Response to Request for Additional Information
Holtec International
Docket No. 71-9325
HI-STAR 180D Transportation Package

Licensing Drawings

Figure 4-8.1: Loading-Unloading Characteristics of O-Ring Seals

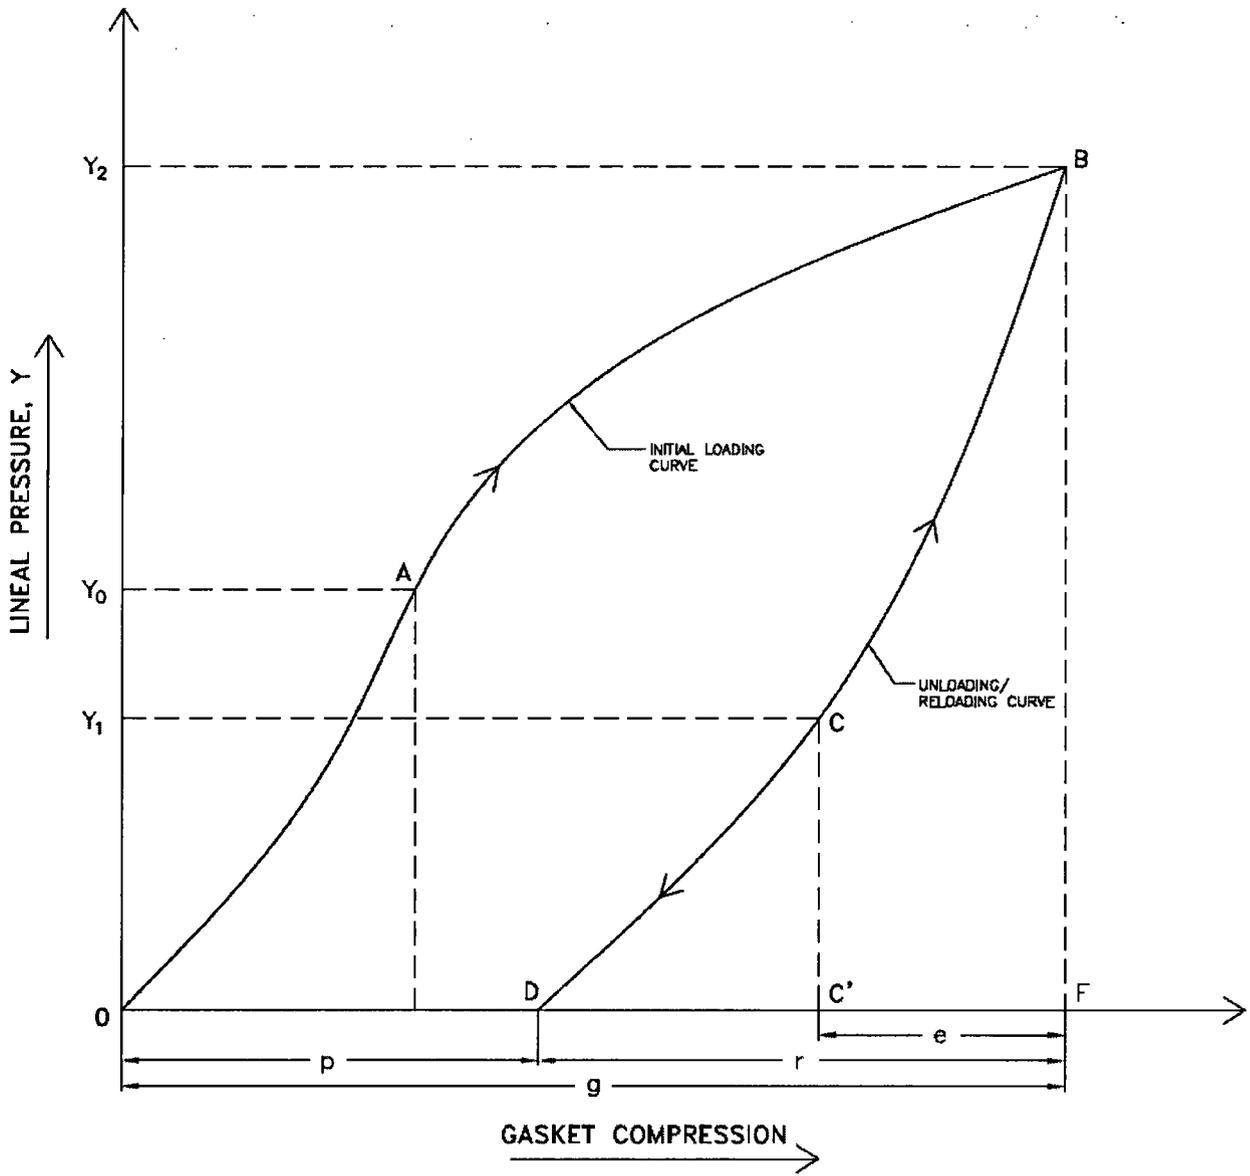
- 4-8 Address the following relative to springback in association with the seal design and the ability of the closure lid seals to remain leaktight under all hypothetical accident events.

- a. Define the springback to maintain leaktight closure lid seals in the SAR.

- b. Provide justification for the minimum numerical value of 0.01339 inches and maximum numerical value of 0.03 inches for springback provided in Table 2.2.12 of the application. Address in Table 2.2.12 of the application if one value or the other is specific to the American Seal & Engineering "Seal option 1" design or the Technetics "Seal option 2" rather than minimum and maximum values being appropriate for both seal options.

- c. Provide clear and complete documentation in Section 2.7 of the application to show that, based on the structural analysis, the closure lid seals for the American Seal & Engineering "Seal option 1" and the Technetics "Seal option 2" will remain leaktight under all hypothetical accident events based on the springback, as well as the associated margin for these analyses.

- d. Explain how the closure lid seals in the American Seal & Engineering "Seal option 1" and Technetics "Seal option 2" have been designed to provide the minimum springback required in Table 2.2.12 of the application and how this can be concluded from the design drawings provided.

Springback has not been defined in the application, although it is a required characteristic in Table 2.2.12 of the application. Springback could refer to "Useful" or "Total" springback. Section 2.7 of the application does not tie the numerical values for springback to the analysis results for each of the hypothetical accident events. Nor does it show the margin associated with each of these analysis. The design drawings provided for the Technetics "Seal option 2" closure lid seals do not tie the springback to the design of the Technetics "Seal option 2" closure lid seals. It is not clear if the design drawings provided for the American Seal & Engineering "Seal option 1" tie the springback to 0.03 inches and how that value and how the minimum value provided in Table 2.2.12 of the application meets that value.

We agree that a clear distinction between the terms "total spring-back" and "useful spring-back" is necessary to avoid incorrect interpretation of the results. For this purpose, Figure 4-8.1 below illustrates the loading/unloading/re-loading curve for a typical O-ring gasket. The terms noted in the figure's legend are used in the explanation below to facilitate presentation.

- a) The term "useful" springback is defined as the amount that the seal can unload without the leakage rate exceeding the required value. In Figure 4-8.1 below, the "useful" springback is the distance between points F and C', denoted by the letter e in the figure. In the prior submission, the term "Total Springback Available" was used which represents the amount that the seal diameter recovers when completely unloaded, i.e., the total springback. In the figure below, the "Total Springback Available" is the distance between point F and the end point (i.e., zero load point) of the unloading curve, D. This distance is denoted by the letter r in the figure.

- b) The following features of the seal's loading/unloading curve are germane to understanding the performance of the bolted joints in HI-STAR 180D:
- (i) At initial compression, upon reaching point A (lineal pressure Y_0), the gasket can seal the joint to the required leakage rate level. However, additional compression is necessary to insure protection against unacceptable leakage.

- (ii) The point B in the figure represents the optimum compression of the seal to insure maximum joint sealworthiness. The depth of the groove in which the gasket sits is accordingly desired to be smaller than the gasket diameter by the amount denoted by letter g. As explained in the Holtec Position Paper DS-337 (submitted as Enclosure 7 to Holtec letter 2178008-NRC), in the controlled compression joint utilized in HI-STAR 180D, any bolt load in excess of compressing the gasket by distance denoted by letter g is taken up by the "land". This compression force serves as the initial buffer (reserve) that protects the seal from decompression under loads trying to pry the joint apart.

- (iii) The gasket follows the unloading/reloading curve in Figure 4-8.1 if it were to decompress and re-compress after initial seating. The gasket responds as an elastic element (no hysteresis) during the unloading/reloading cycle.

- (iv) As the gasket is made to relax during unloading, its lineal pressure, Y , drops. The pressure corresponding to point C is the minimum required pressure to meet the minimum specified leak rate.

- (v) If the gasket were to continue to unload, then the lineal pressure will fall below the threshold pressure Y_1 , and the leak rate may begin to exceed the specified minimum. Nevertheless, the gasket will continue to load/unload along the "elastic" curve under all subsequent cycles.

- (vi) In order to maintain joint seal, it is necessary that the compression of the seal lie between points F and C'; i.e., in the useful springback range.

- (vii) The total recovery, denoted by letter r, is substantially greater than the useful (elastic) springback recovery, denoted by letter e.

The structural analyses reported in SAR sections 2.6 and 2.7 conclude that the seal will remain fully seated (at point B in Figure 4-8.1) after all of the analyzed Level A and Level D accidents. In other words, the seal springback at the end of the analyzed accident is zero. As an example, Figure 4-8.2 below shows the relative gap between the top flange and inner lid under the 30' end drop case, which is measured at the inner edge of the inner seal groove. While the gap opens up momentarily during the course of the drop, the springback of the seal after the accident is zero. Seal testing has demonstrated that the seal returns to the leak-tight condition after opening and returning to fully seated. A value of 0.01" was selected as the limit for minimum useful springback to provide additional margin against leakage of the seal. SAR sections 2.6 and 2.7 have been revised to provide the necessary clarification.
